Comments on applications for referral under the COVID-19 Recovery (Fast-track Consenting) Act 2020

Project name	Stevensons Crescent
General comment – potential benefits	Will generate additional employment in the local region during the construction phase. Will add additional housing supply in the Auckland region.
General comment – significant issues	1. The proposal is contrary to the objectives and policies of the Future Urban Zone. It is likely that under the existing AUP planning regime, the application would be publicly notified as it is significantly out of character to the current existing and planned character. 2. No Private Plan change lodged prior to the proposal being referred to the Fast-track consenting process; and the proposal does not include a Structure Plan as required under AUP. 3. Auckland Transport imminent route protection Notice of Requirement (NoR) for the upgrade of Dairy Flat Highway and widening the roads (eta: May 2023) – see Auckland Transport's Comments below. 4. Proposal is not aligned with the current planning documents and regional strategic documents. 5. Potential wetland areas within the site and along the proposed access (road to vest), (insuffici

Figure 1: Wastewater network to be ensured as 225mm or more

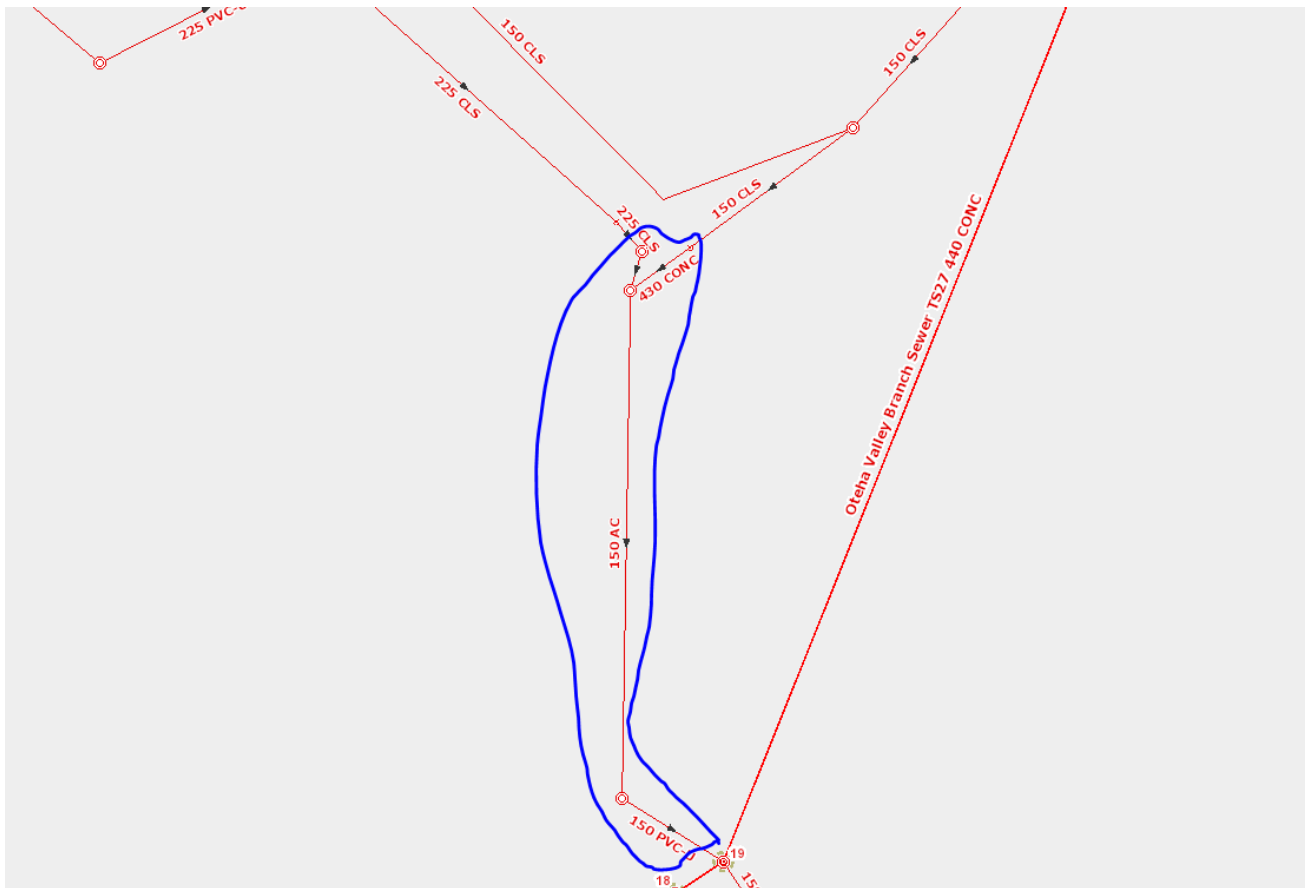
The developer must conduct a survey for the entire downstream local network until MH 19 (GIS ID: 257494) confirming the pipe sizes. Given that the below network from **MH GIS ID:399517 to Transmission MH GIS ID: 2574794** is 225mm or more, the existing network has enough capacity to cater to this development.
